Subj: **Phase I Cultural Resources Assessment of the Oakmont of Agoura Hills Project  
(Envicom Project #56-635-101)**

Subject: Addendum to Geotechnical Investigation Report  
Response to Geotechnical Review Sheet  
Proposed Oakmont of Agoura Hills Senior Facility  
29353 Canwood Street  
Agoura Hills, California

**CITY OF AGOURA HILLS - GEOTECHNICAL REVIEW SHEET**

Subject: Addendum to Geotechnical Investigation Report  
Response to Geotechnical Review Sheet Dated July 11, 2016  
Proposed Oakmont of Agoura Hills Senior Facility  
29353 Canwood Street  
Agoura Hills, California

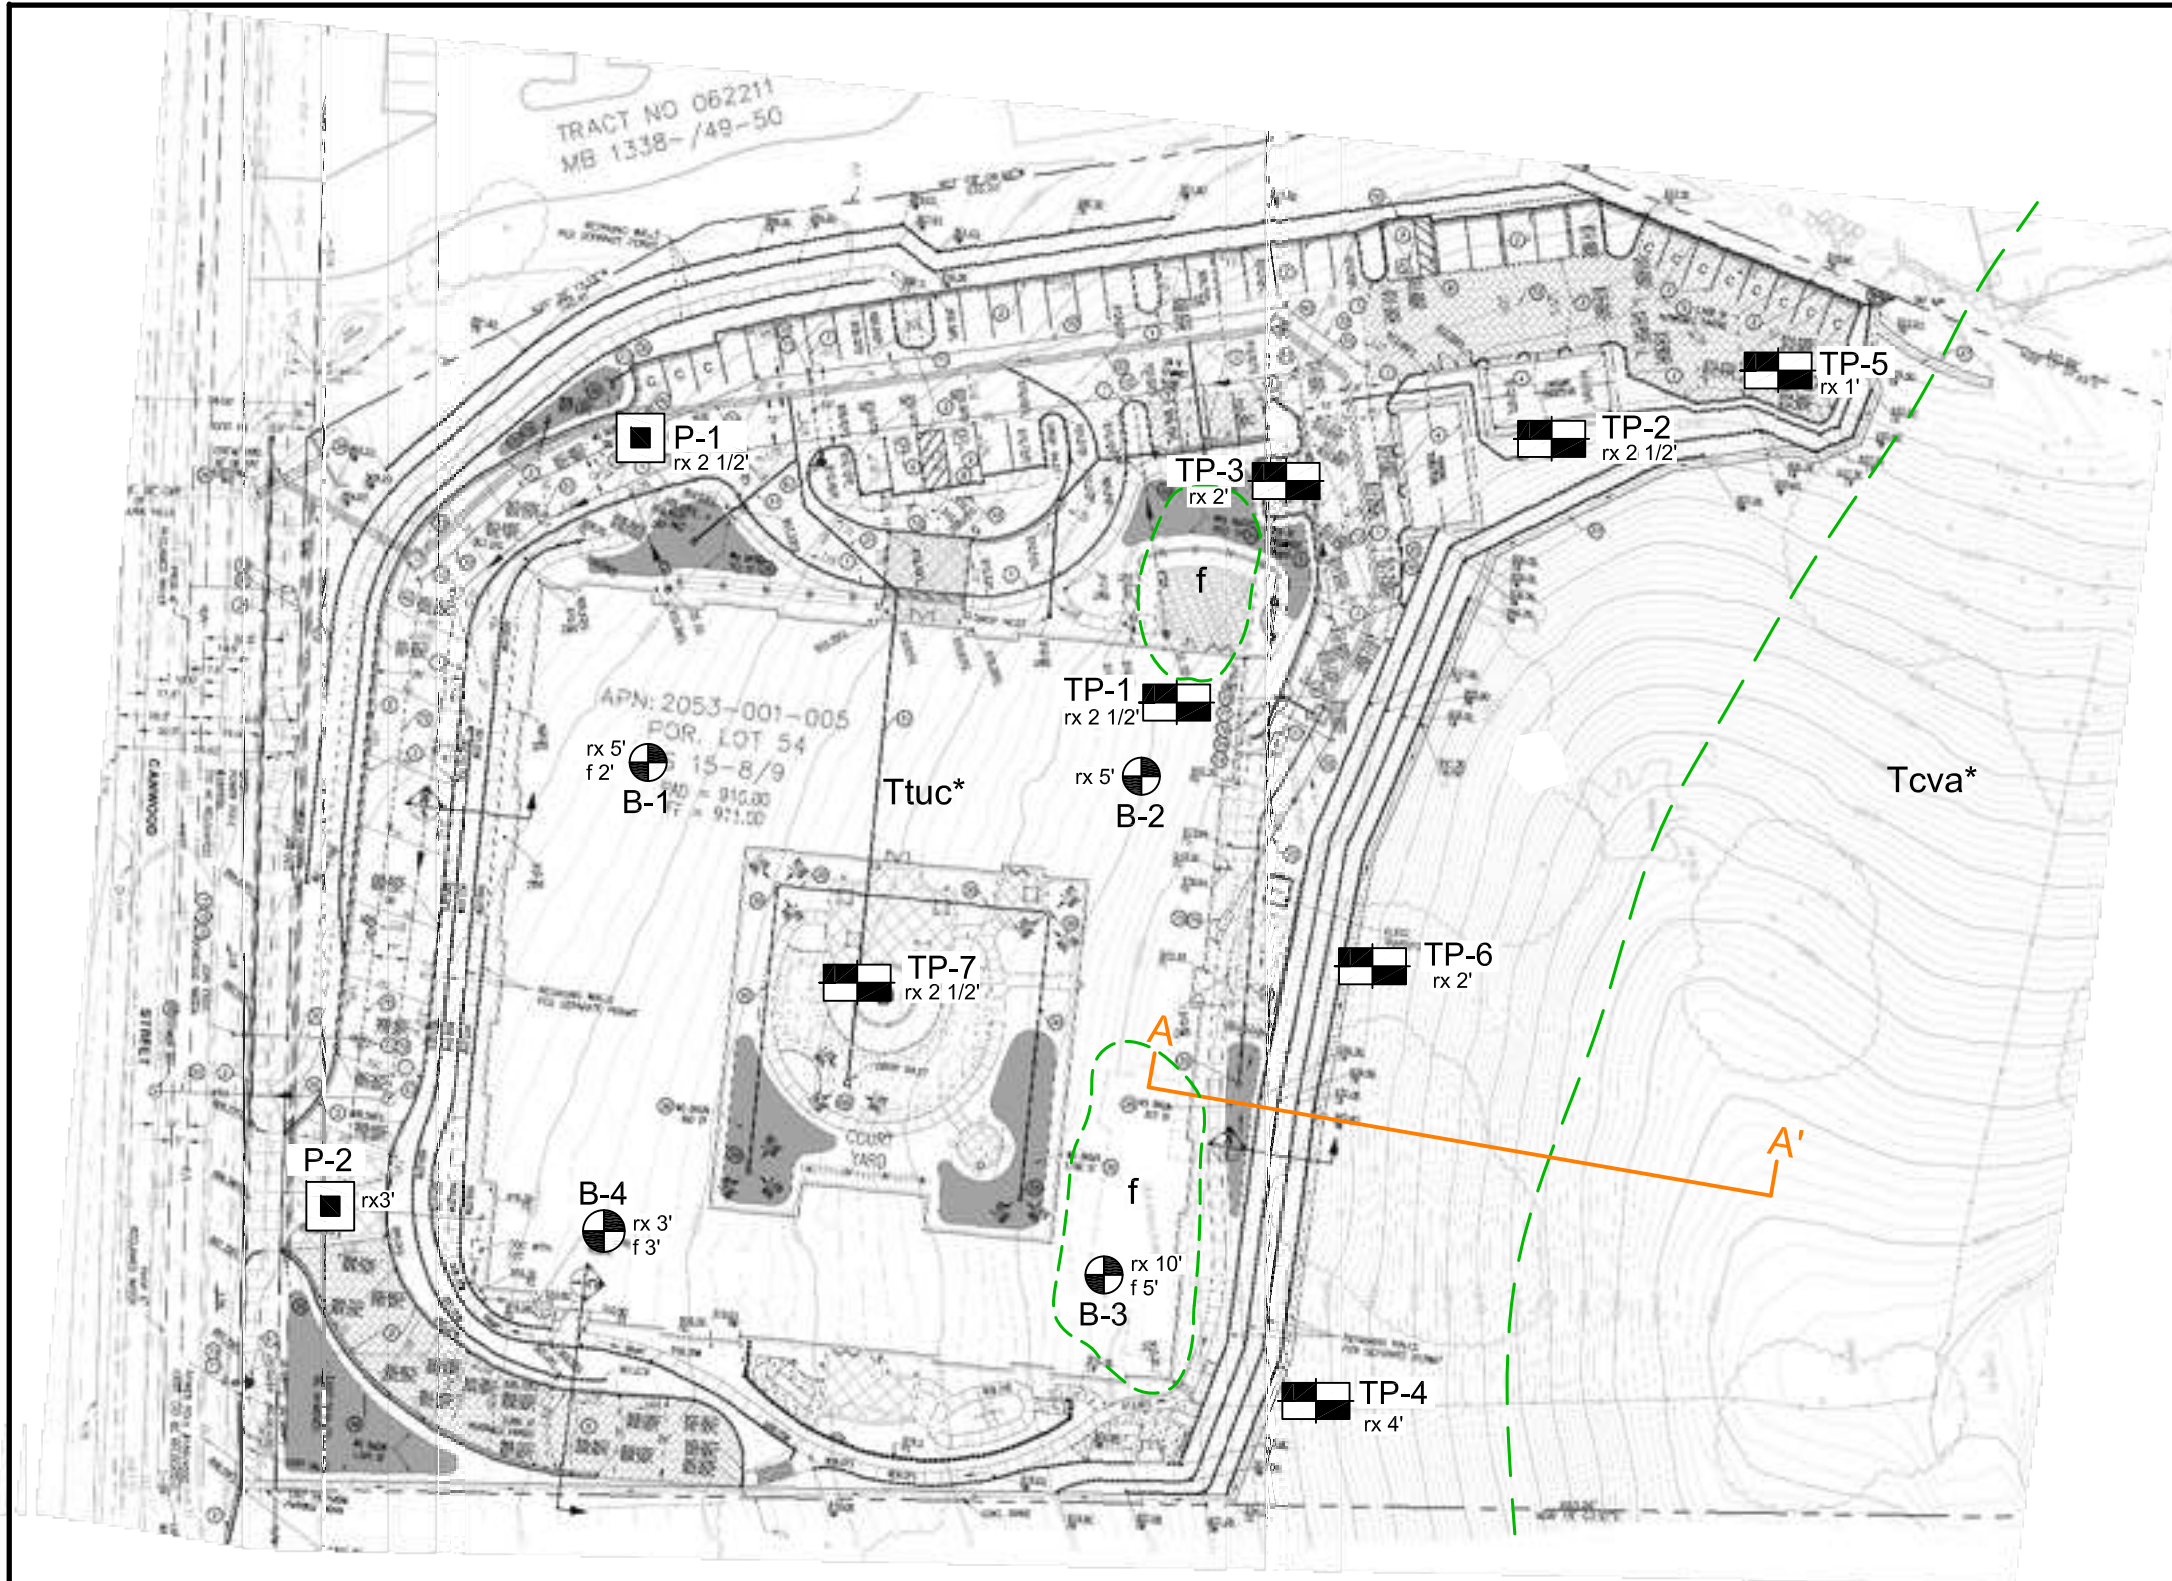
- 1. The consultant should provide an updated geologic map based on a legible copy of the latest development plan. The map should include all geologic data including contacts between all geologic units (including alluvial units if appropriate), structural information and a complete geologic legend. The consultant should discuss the basis for the location of the contact between Tcva and Ttuc (sic) indicated on the map.*

1. The consultant should provide an updated geologic map based on a legible copy of the latest development plan. The map should include all geologic data including contacts between all geologic units (including alluvial units if appropriate), structural information and a complete geologic legend. The consultant should discuss the basis for the location of the contact between Tova and T1vc (sic) indicated on the map.

An updated geological and geotechnical map on the basis of the proposed grading plan, prepared by Huitt-Zollars, Inc., dated (last saved) April 16, 2016, is attached hereto.

GEOLOGIC CROSS SECTION A-A'		
FOR:	OAKMONT SENIOR LIVING	ENCLOSURE "A-2.2"
DATE:	JUNE 2016	JOB NUMBER 15473-3A
GEOTECHNICAL INVESTIGATION OAKMONT OF AGOURA HILLS SENIOR FACILITY APN 2053-001-005 29353 CANWOOD STREET AGOURA HILLS, CALIFORNIA

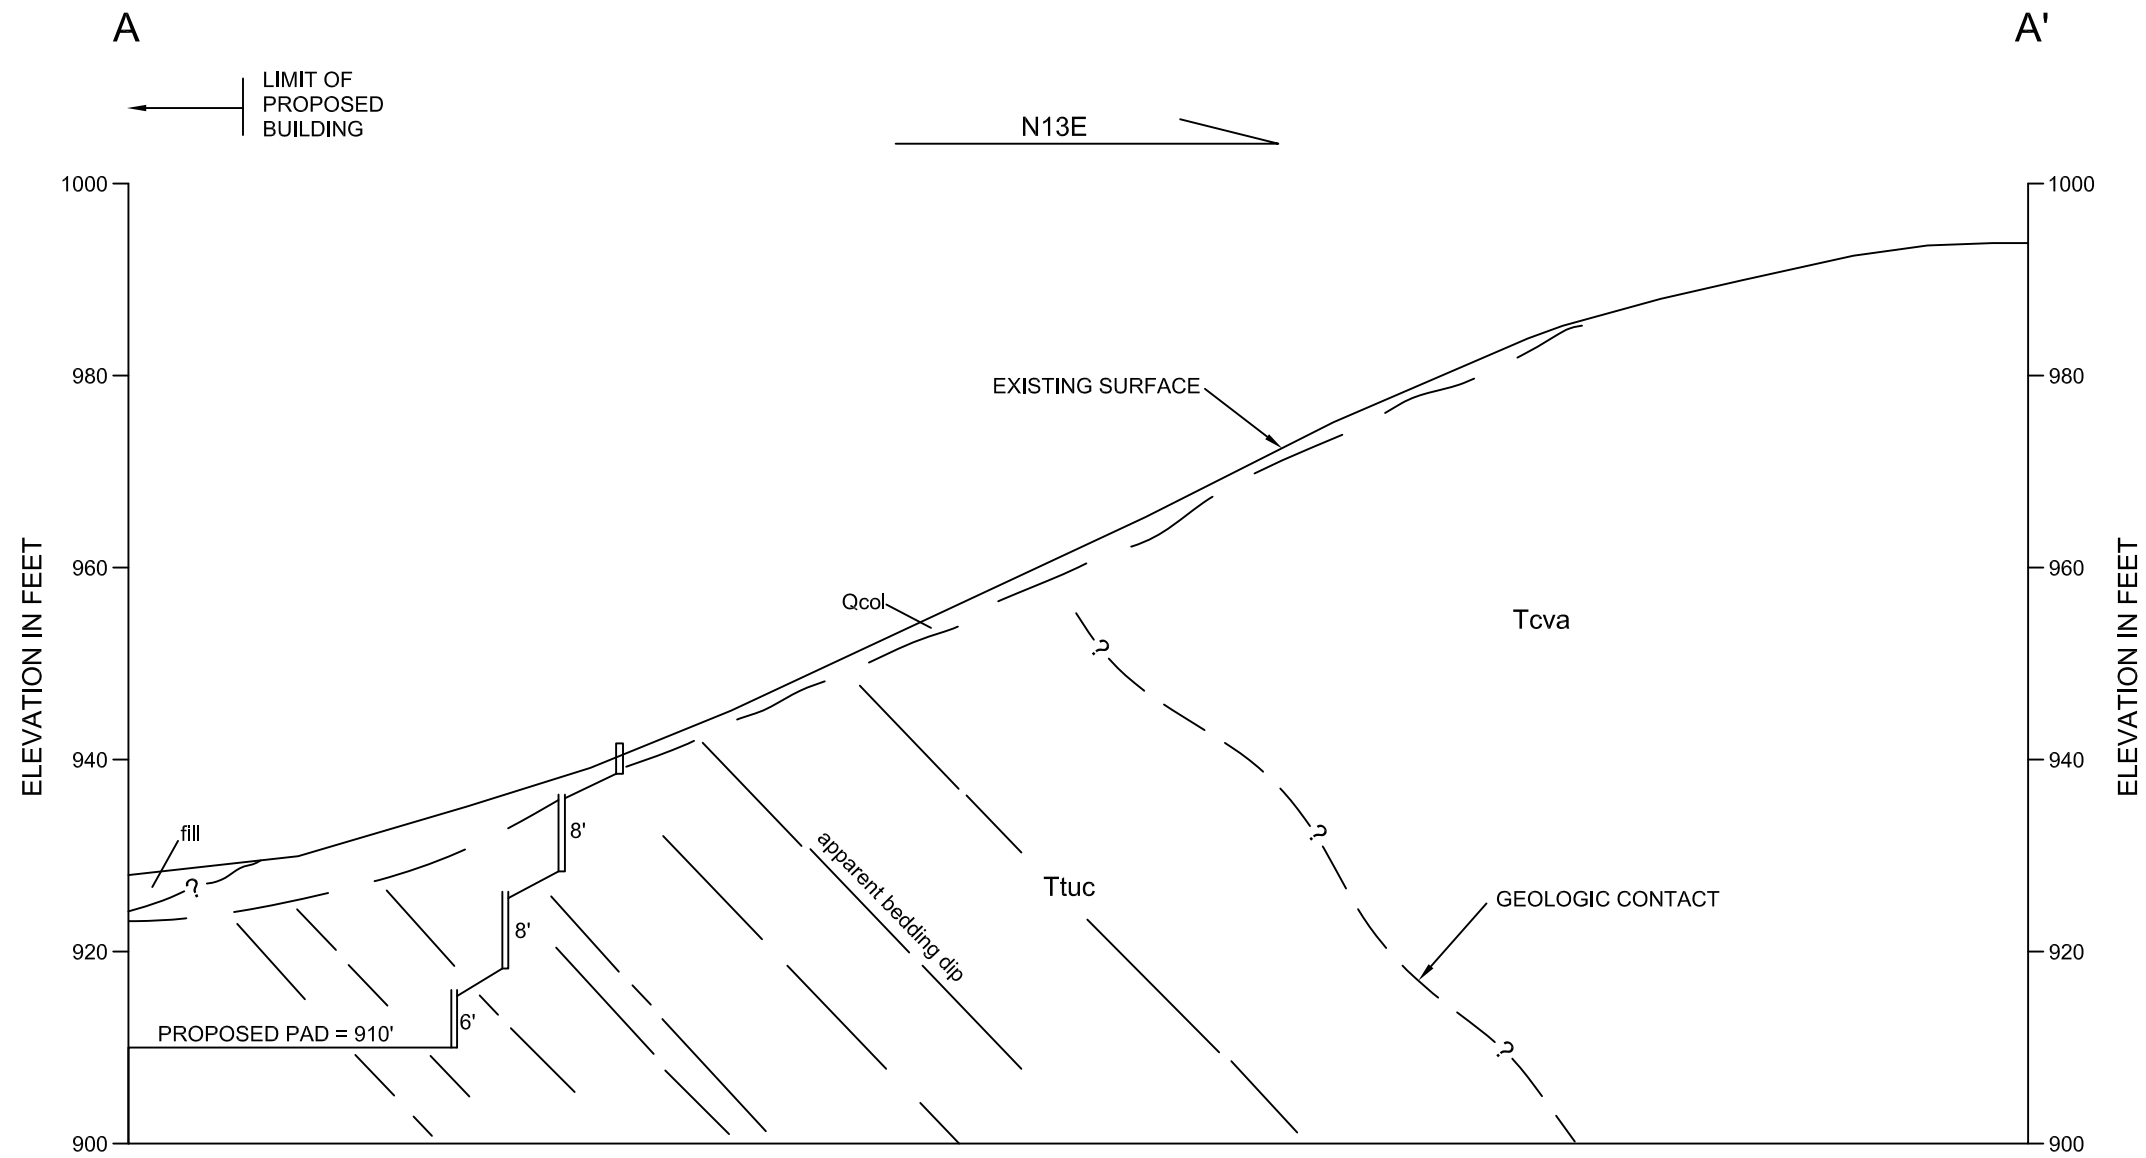
*1. The consultant should review development plans as they become available to verify compliance with recommendations in the above-referenced reports. A geotechnical map using the proposed grading plan as a base map should be included. Cross sections should be updated as necessary*

1. The consultant should review development plans as they become available to verify compliance with recommendations in the above-referenced reports. A geotechnical map using the proposed grading plan as base map should be included. Cross-sections should be updated as necessary to reflect changes in the proposed grading relative to the current grading concept. Additional geotechnical recommendations should be provided as necessary.

An updated geological and geotechnical map on the basis of the proposed grading plan, prepared by Huitt-Zollars, Inc., dated (last saved) April 16, 2016, is attached hereto.

<b>BUILDING SETBACK DETAIL</b>		
FOR: <b>OAKMONT SENIOR LIVING</b>	GEO TECHNICAL INVESTIGATION OAKMONT OF AGOURA HILLS SENIOR FACILITY APN 2053-001-005 29353 CANWOOD STREET AGOURA HILLS, CALIFORNIA	ENCLOSURE <b>"B-1"</b>
DATE: <b>JUNE 2016</b>		JOB NUMBER <b>15473-3A</b>
<b>CHJ</b> Consultants

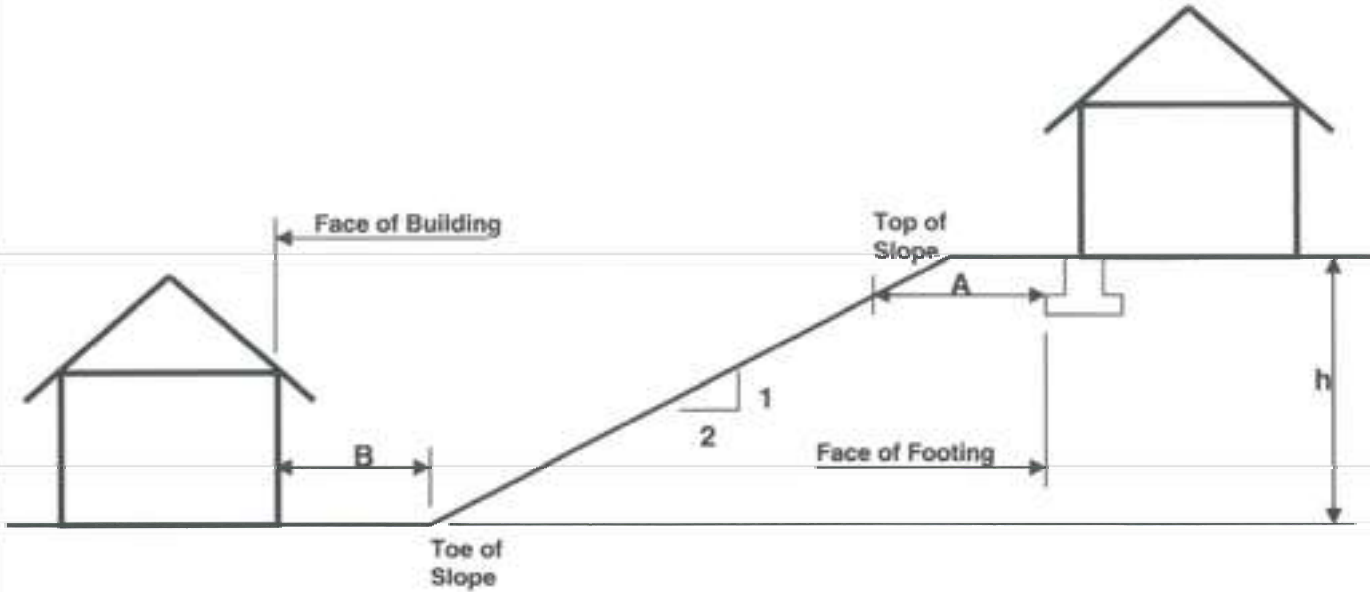
- 4. The consultant should provide recommendations for the foundation to slope setback in accordance with the City of Agoura Hills building ordinance.*
